Safety Recall: 2018-19 Accord Fuel Pump Motor

Supersedes A20-043, dated May 29, 2020, to revise the information highlighted in **yellow**

REVISION SUMMARY

9.1. Install the new spacer, O-ring, and wire harness to the new fuel pump.

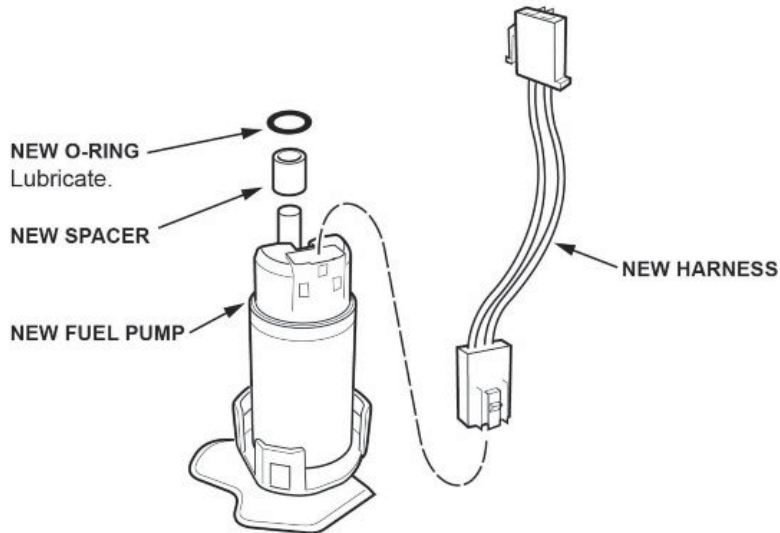
- Under PARTS INFORMATION, additional text was added.
- Under REPAIR PROCEDURE step 9, the NOTES and substep 9.2 were revised.

- **The O-ring must be installed on the pump as shown, not on the fuel filter side.**
- Coat the O-ring with clean engine oil; do not use any other oil or fluid.
- Do not pinch the O-ring during installation.
- When connecting the wire harness, make sure the connection is secure and the connectors are firmly locked into place.
- Use all the new parts supplied in each replacement kit.
